Whiting Street PD&E Study

Pond Siting Report

April 2024

THEA Project No: HI-0112

WHITING STREET PD&E STUDY EXISTING DRAINAGE MAP

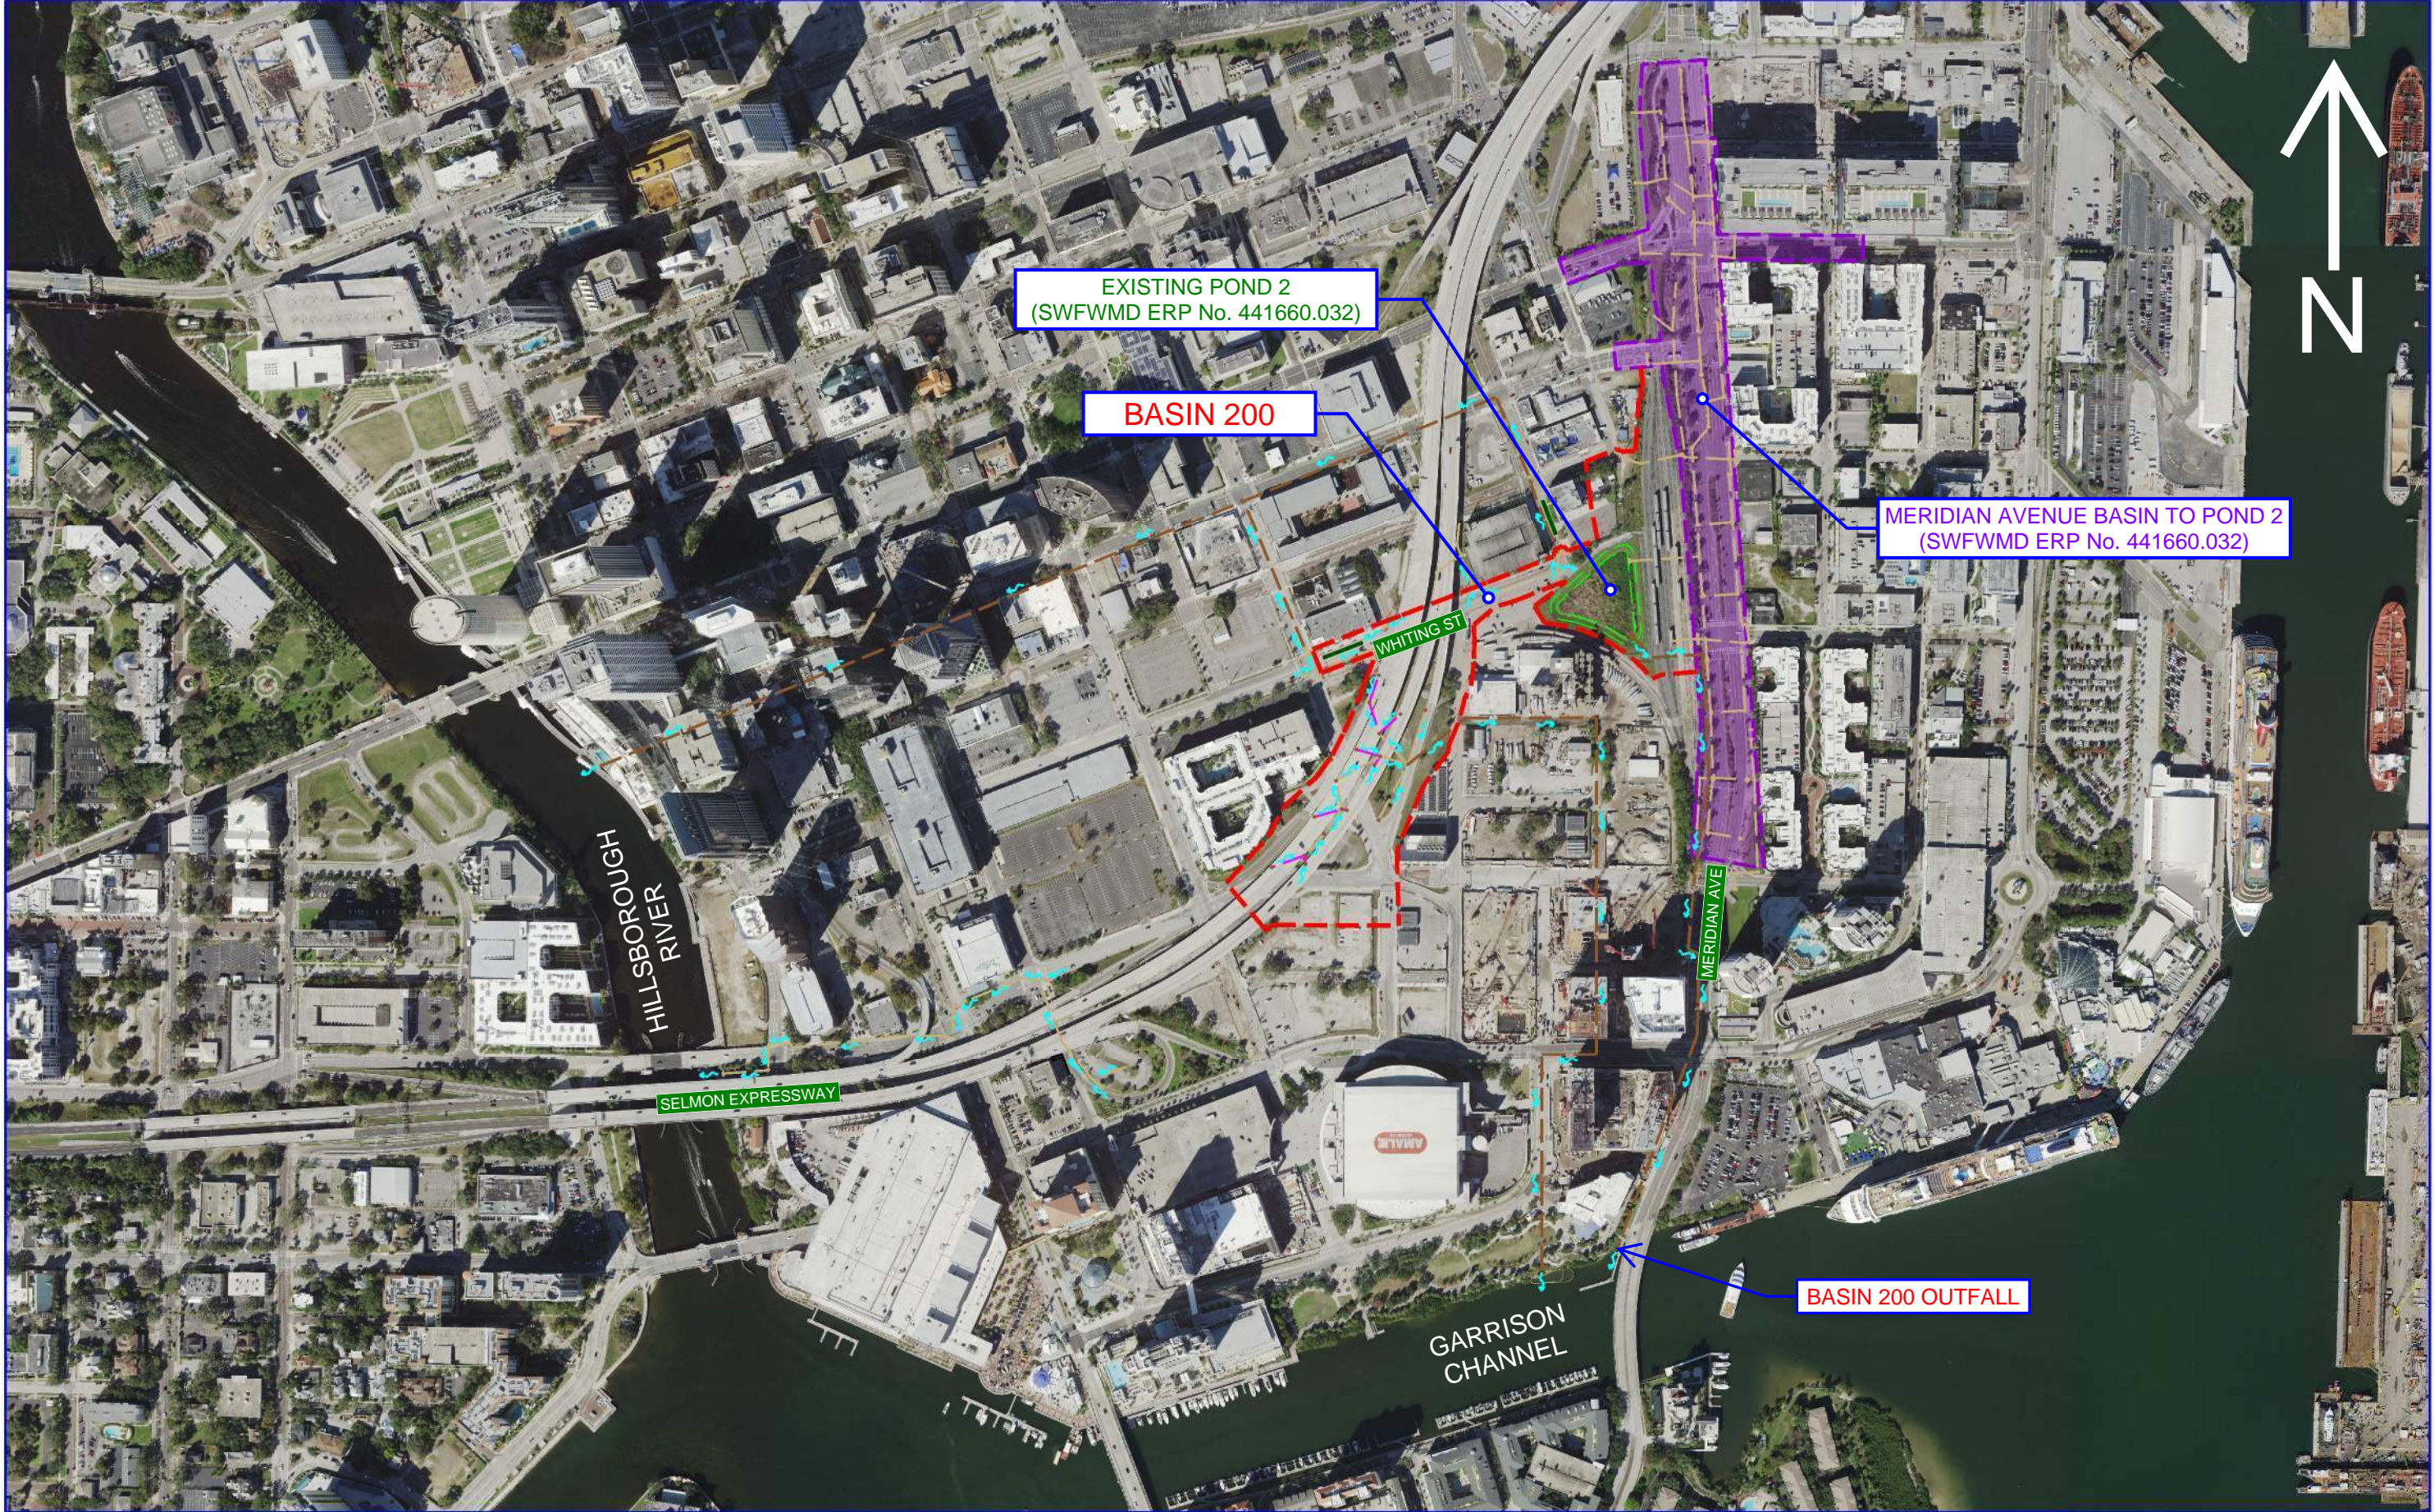
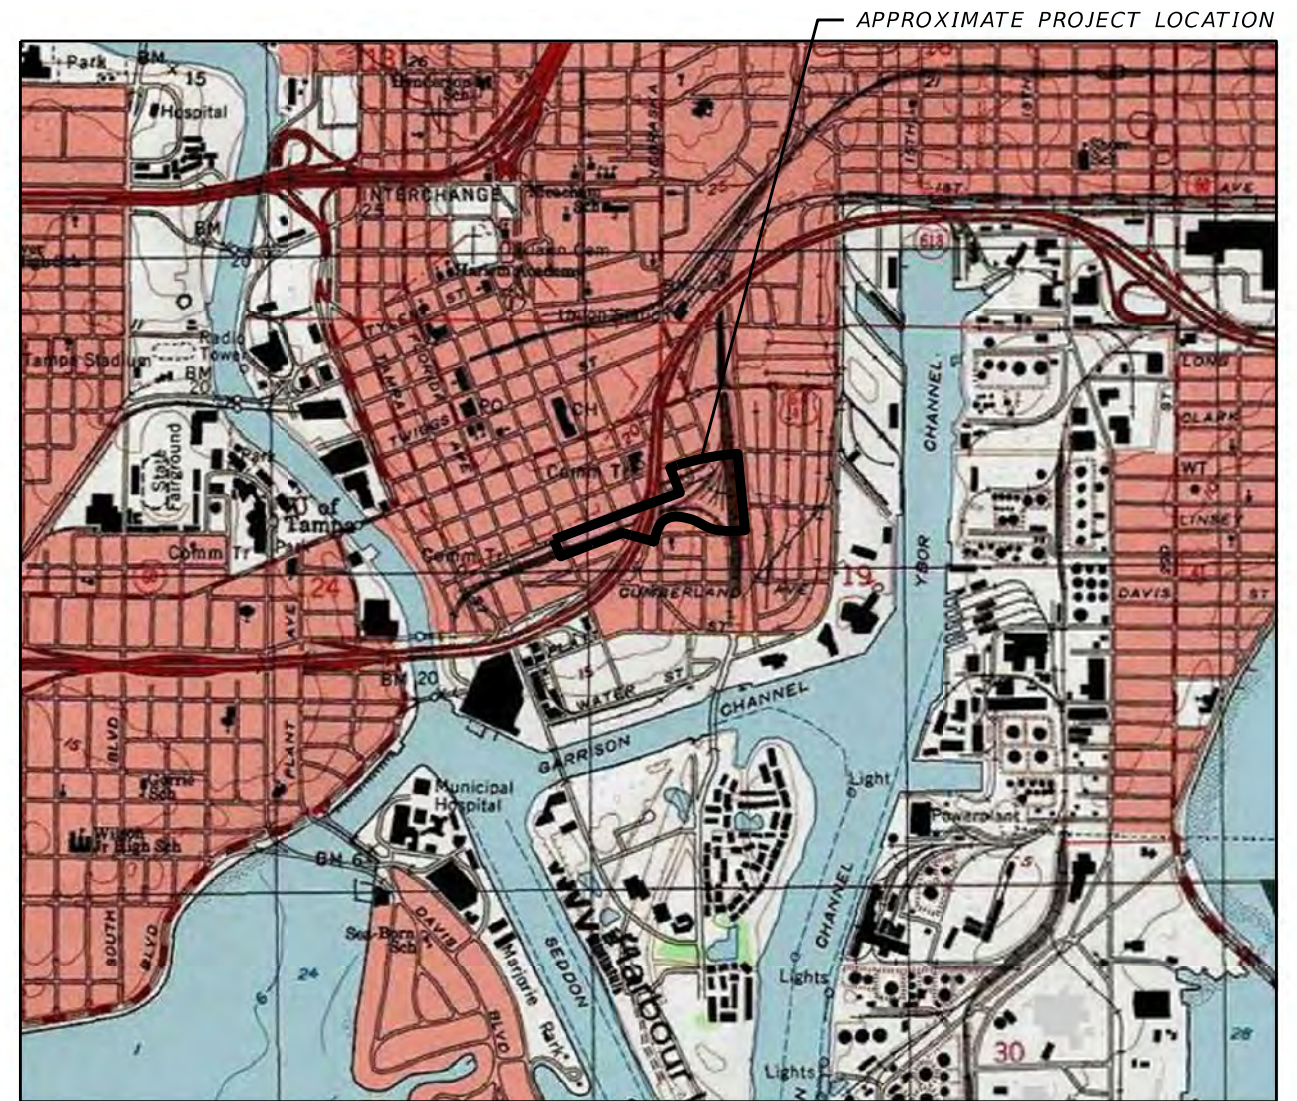
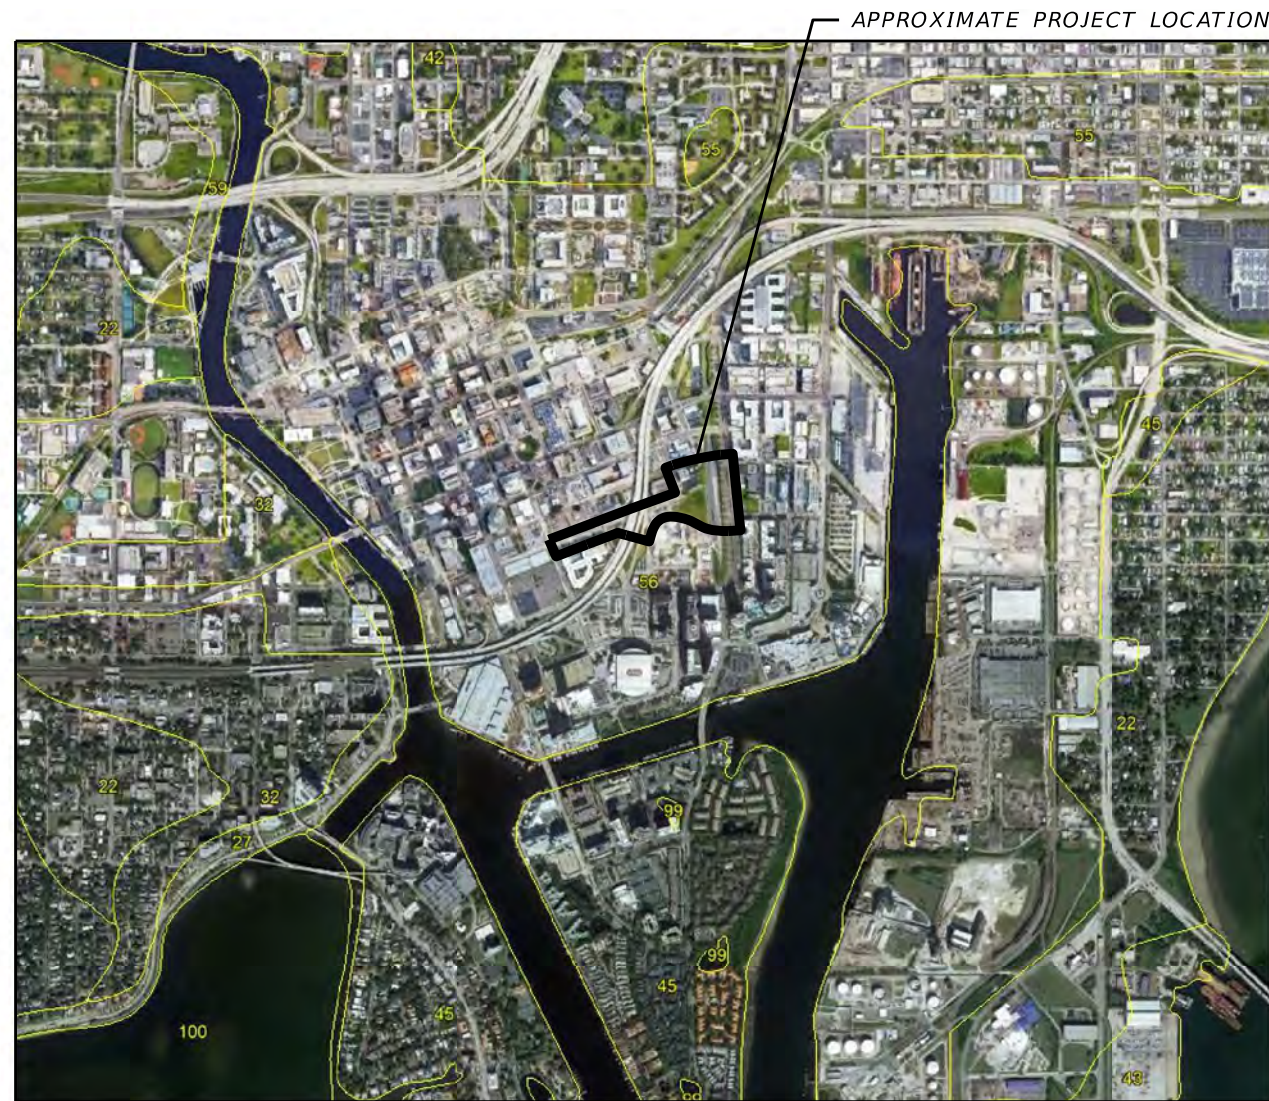
16. PDF Page 37 of 69: The brownish lines blend into the Aerial and should be changed to a different color. What do these lines depict? It appears that flow arrows are there (green) but that the scale provided the flow arrows cannot be read. Please provide larger flow arrows or, as an alternative, include flow arrows on the Pond exhibits later in the document.

Response: The drainage map will be revised for clarity. Flow arrows will be enlarged.
Follow-up Comment: Response accepted.
17. Sheet 42 of 69: Pond 200-1 and Pond 200-2 are depicted differently here than they are in subsequent exhibits. Please reconcile.
